**WCHA
WEST HEMPFIELD TOWNHOUSES
EXTERIOR RENOVATIONS**

ADDENDUM NO.1

DATE OF ISSUE: JULY 23, 2024

2 HANDRAIL ELEVATION
 A1.00 SCALE: 1 1/2" = 1'-0"

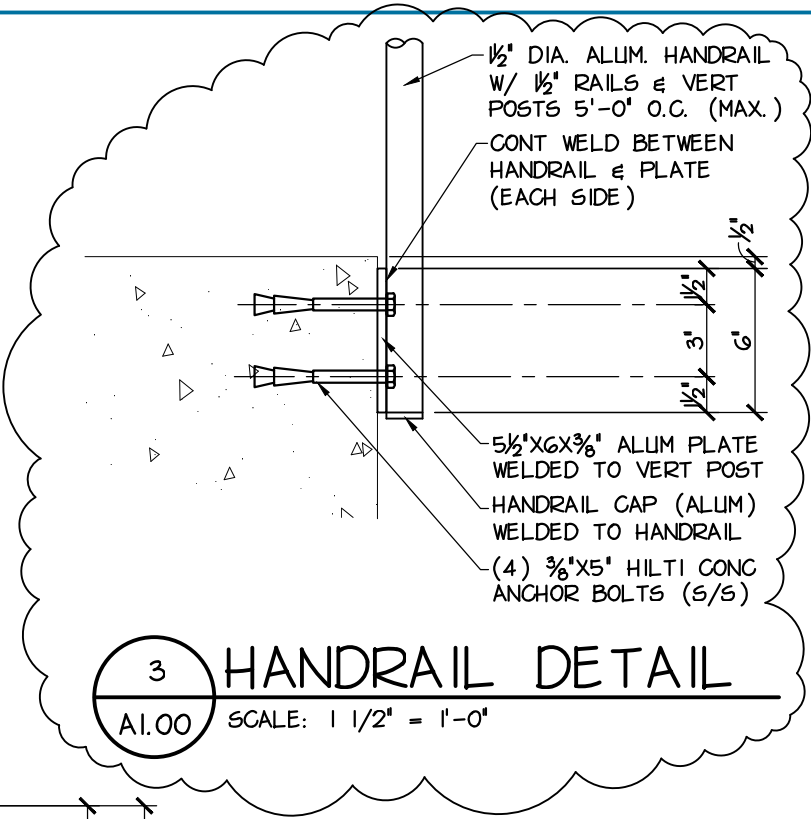
DETAIL 2/A1.00 – Revise this detail as indicated on the revised drawing.

NOTE:
 HANDRAIL TO MAINTAIN ALL CODE REQUIRED DIMENSIONS APPROPRIATE FOR EACH STAIR TYPE (3 TREAD, 4 TREAD AND 5 TREAD STAIRS).
